APPLICATION NO.	FILING DATE	FIRST NAMED INVENTOR	ATTORNEY DOCKET NO.	CONFIRMATION NO.
10/717,240	11/18/2003	Mike MacArthur	ROB3108.03A	6893

Office Action Summary

DETAILED ACTION

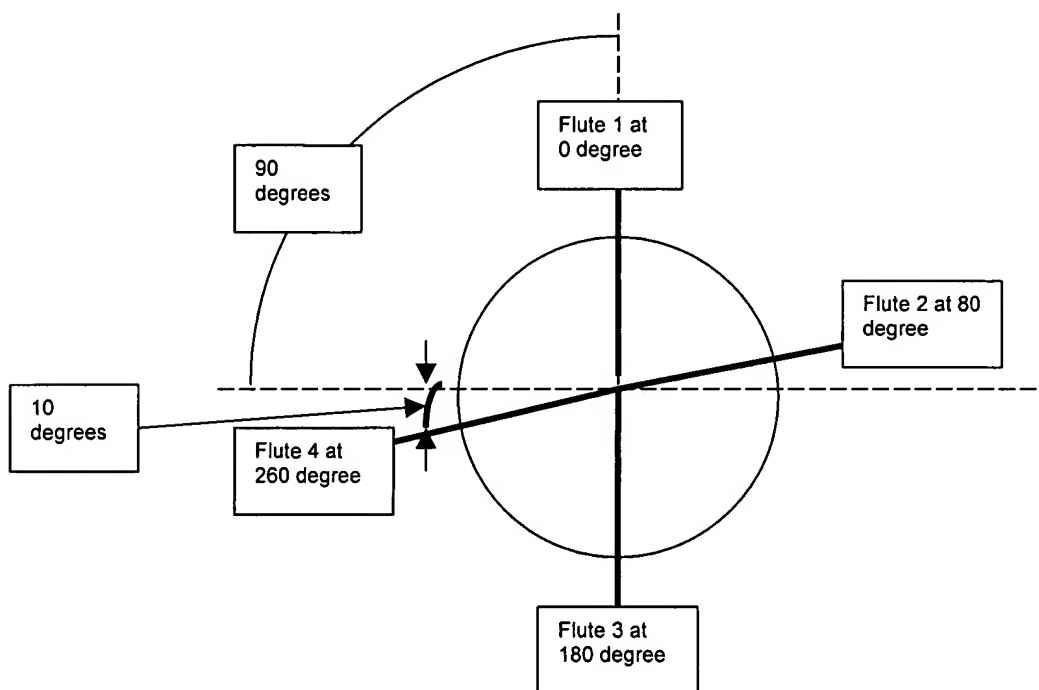
of paired flutes". Regarding claims 14 and 15, FLYNN ET AL. teaches flutes aligned directly from one another: four flutes located at 0, 80, 180 and 260 degrees (Page 2, paragraph 40). This configuration shows (see figure below) that the second-forth pair of flutes are off-set from the first-third pair of flutes by an amount of 10 degrees (which meets the limitation of between 1-10 degrees claimed in claims 14 and 15).
